CHAPÉU E PRATELEIRA ELE COM PERFIL FRONTAL

CI - 07/NOV/25

CORNER SHELVES AND HATS WITH FRONT PROFILE

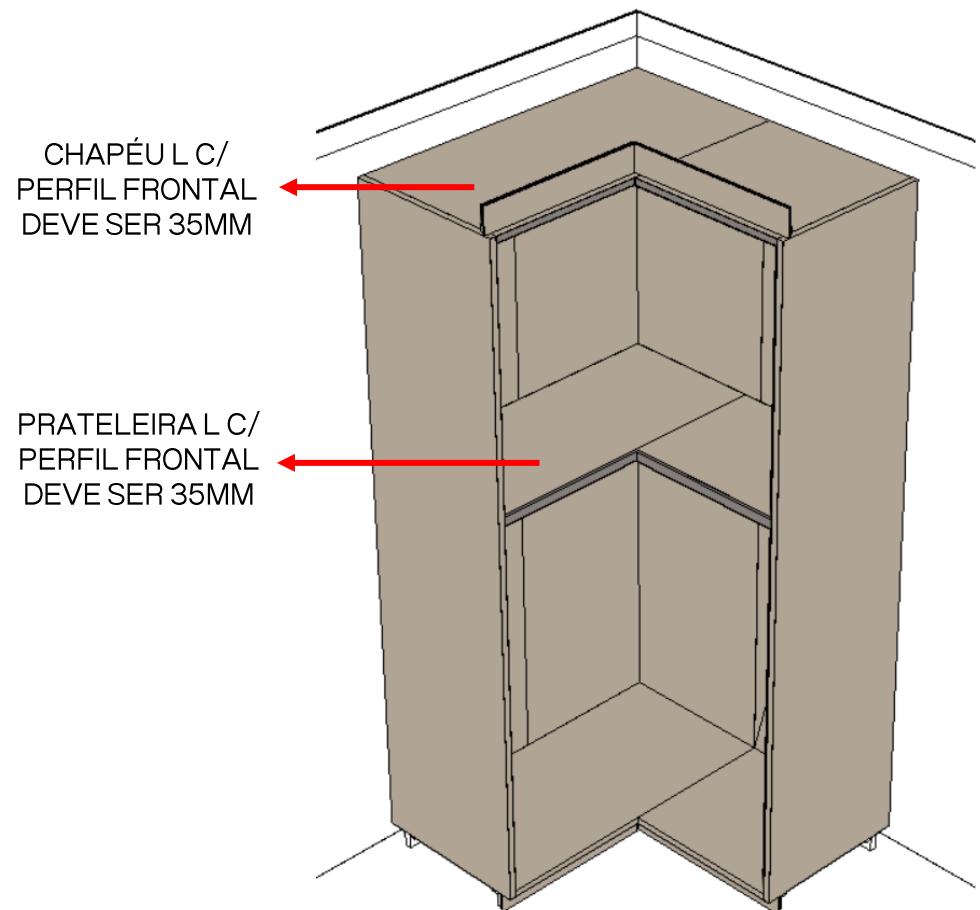
Informamos **não será mais possível fazer chapéu ou prateleira em “L” de 25mm com perfil frontal**. Caso seja necessário utilizar o perfil frontal, deverá ser alterada a espessura da prateleira para 35mm. Isso será padronizado dessa forma, porque a junção dos perfis na prateleira L de 25mm não fica boa e tem gerado problemas técnicos. Para os chapéus, em breve será incluído em sistema a opção de espessura de 35mm para esses casos.

Essa regra vale apenas para armários em L, portanto em módulos retos ainda será possível fazer chapéu e prateleira de 25mm com perfil frontal.

We inform you **it will no longer be possible to make a 25mm corner hat or shelf with front profile.** If it is necessary to use the front profile, the thickness of the shelf should be changed to 35mm. This will be standardized in this way, because the junction of the profiles on the 25mm corner shelf is not good and has generated technical problems. For the corner hats, the option of 35mm thickness will soon be included in the system.

This rule only applies to L-shaped cabinets, so in straight modules it will still be possible to use a 25mm hat or shelf with a front profile.
